Product Change Notification—PCN001203**Jun 25, 2026**

- **CP-132EL Series**
- **CP-118E-A-I/138E-A-I Series**
- **CP-134EL-A-I Series**
- **CP-114EL Series**

Product photo of the **CP-132EL** models

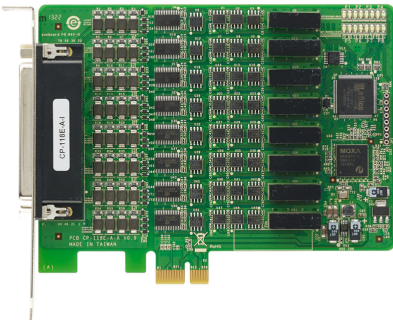
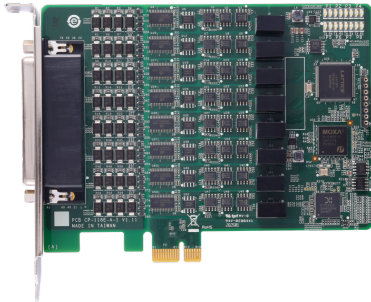
- An enhanced board design by incorporating a PCIe switch bridge.

CP-132EL-DB9M	
Current Version HW Rev 1.3.1	New Version HW Rev 1.4.0

CP-132EL-I-DB9M	
Current Version HW Rev 1.4.1	New Version HW Rev 1.5.0

Product photo of the **CP-118E-A-I w/o cable**

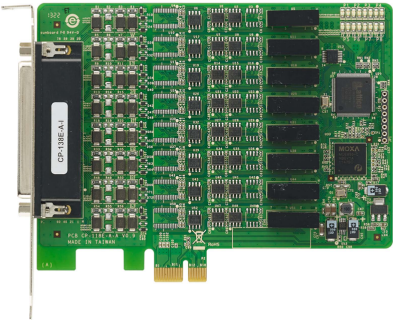
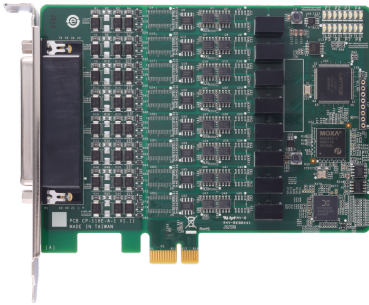
CP-118E-A-I w/o cable	
Current Version HW Rev 1.0.1	New Version HW Rev 1.1.0

Product photo of the **CP-138E-A-I w/o cable**

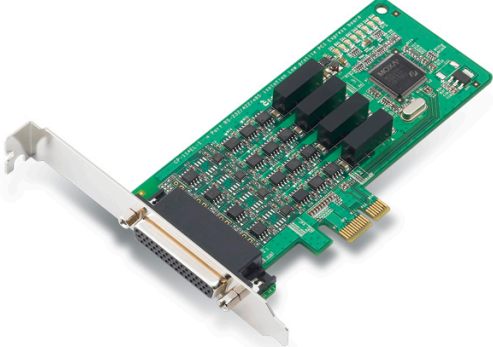
CP-138E-A-I w/o cable	
Current Version HW Rev 1.0.1	New Version HW Rev 1.1.0
